Variance application: further questions

Case#: ZBA 24-04

Applicant: John C & Mary Ellen Mathewson

Address: 9 Forty Acres Road

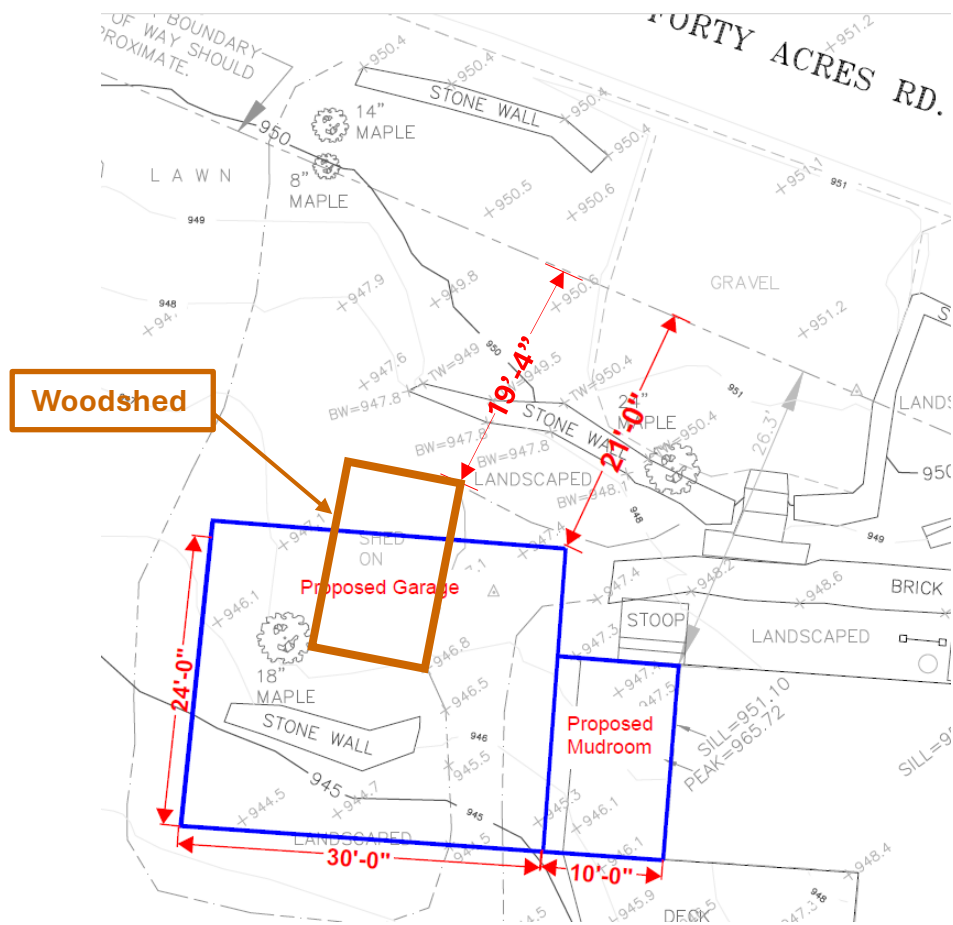
- 1) The board wants clarification of where the property line along Forty Acres Road is on the map shown in the meeting, including some information regarding the accuracy of the property line.
- 2) The board would like some better justification for putting the garage 8 feet closer to the road than the front of the existing house.
- 3) The board would like some information regarding wetlands seen from Forty Acres Road.

The main issue with the proposed location of the garage is that I have not shown that to move it back, away from the right-of-way, so that the front is in line with the front of the existing house would result in an unnecessary hardship.

The hardships that will result from moving the garage back are:

- Loss of use of mature lawn and gardens.
- Greatly reduced views of woods behind the house.

There is no gain to the public that results from moving garage back:

- Area in front of garage will be driveway and retaining walls, so will be built on anyway. Effect will only be to increase driveway length from 27 feet to 35 feet.
- The proposed garage location results in increased setback from the right-of-way, as the existing woodshed with setback of 19' 4" will be torn down and replaced by the garage with setback of 21' 0". More details are on the following slide.
